Construction Change Directive

PROJECT: (name and address) Highland Township Fire Station 1 - PIA

Directive Number: 002

Date: June 15, 2020

SHEET NO. C-2

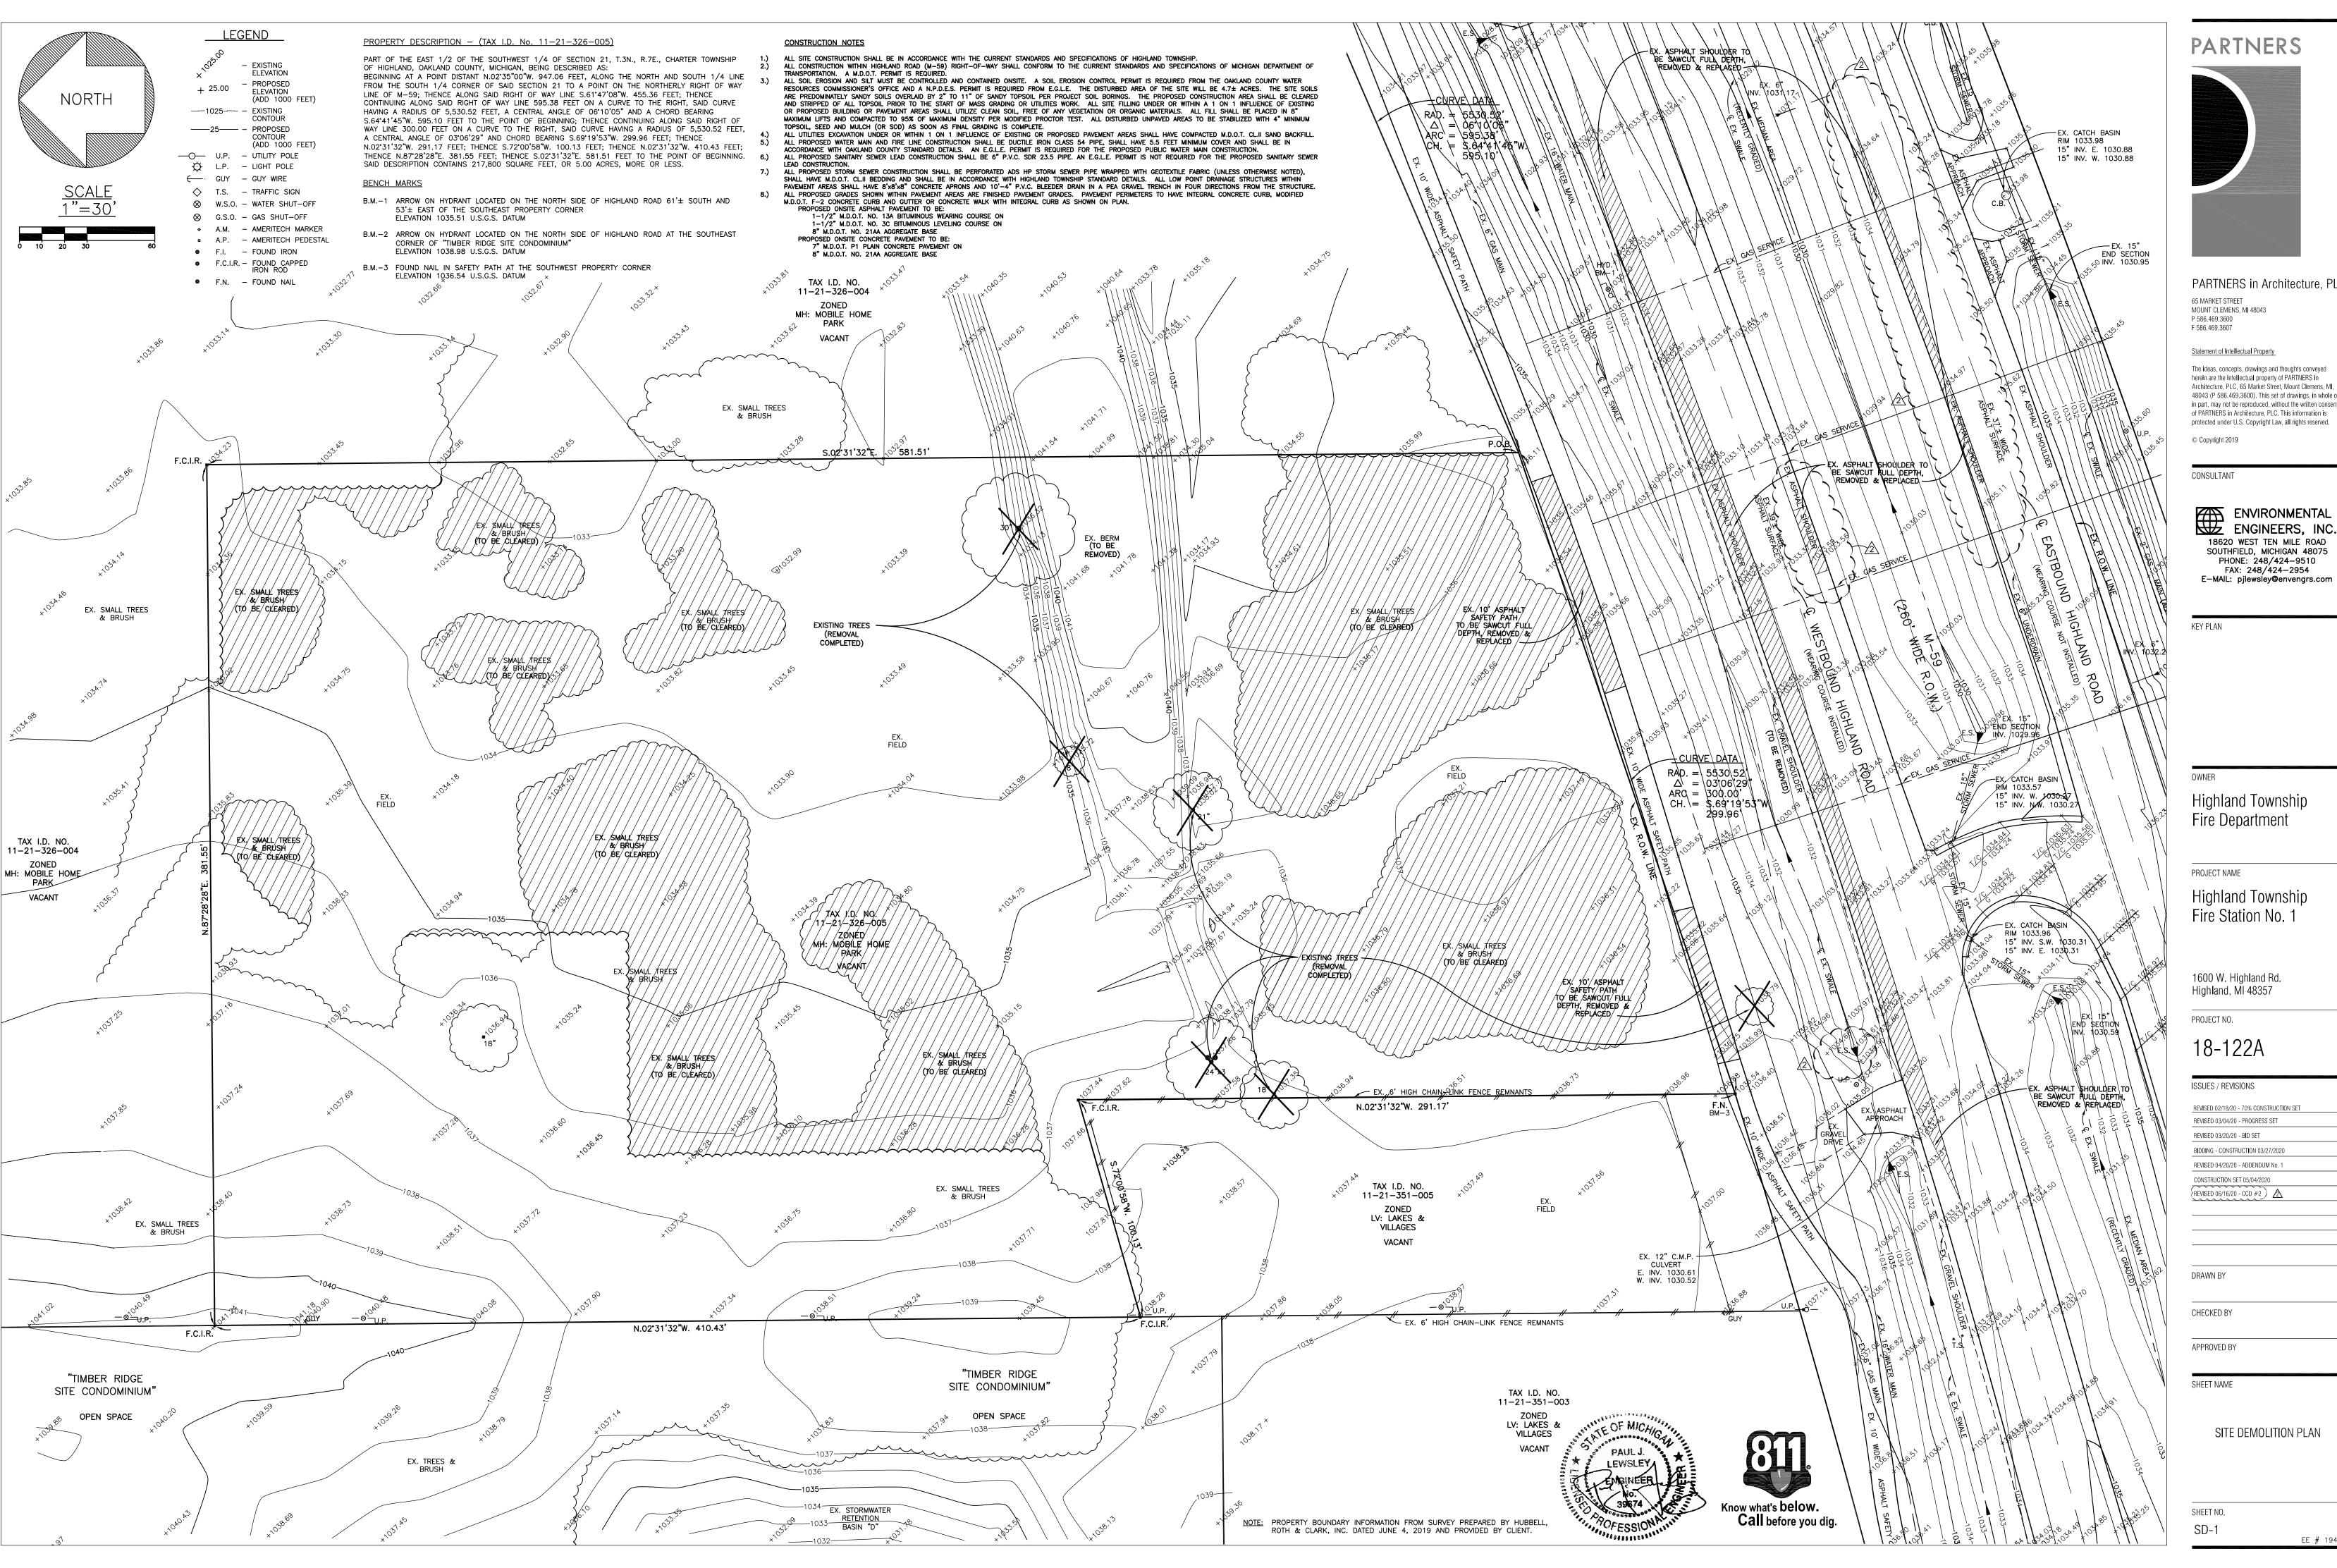
- 1. Revision to the civil plans based on MDOT requirements.
- 2. Extend a cold water line to the water closet in the Apparatus Bay.
- 3. Add power for the SCBA compressor.
- 4. Revise the layout for the Apparatus Laundry and New Extractor.

Mezzanine Level Floor Plan - Domestic Water & gas

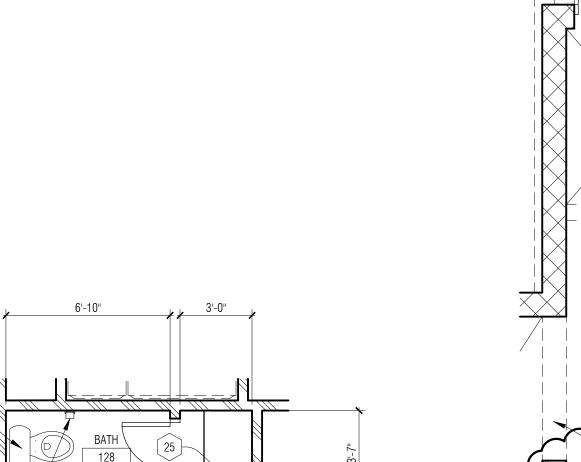
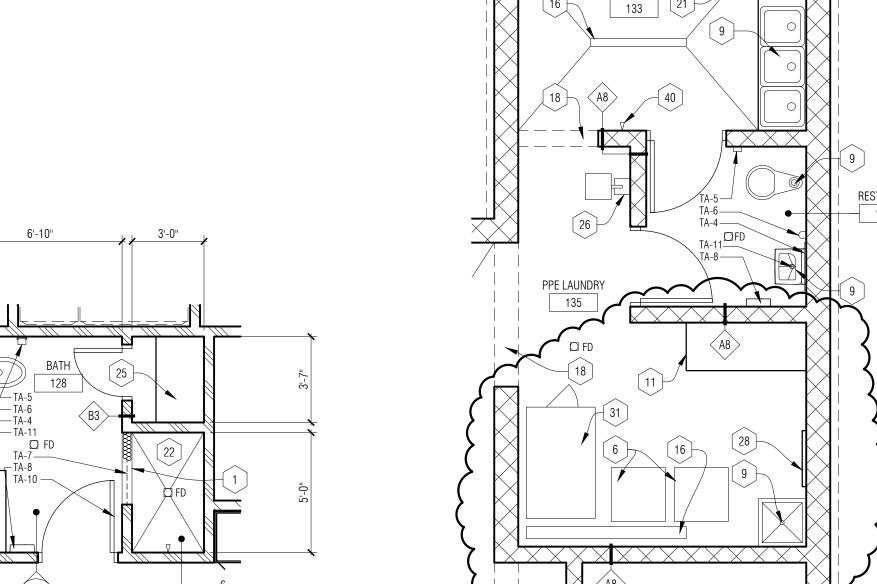
1) EXTEND DOMESTIC WATER IN WALL TO SINK. KEEP TIGHT TO INTERIOR OF WALL. PROVIDE MINIMUM 2" RIGID INSULATION BEHIND PIPE AN SEAL TO STUD AND ALL SEAMS.
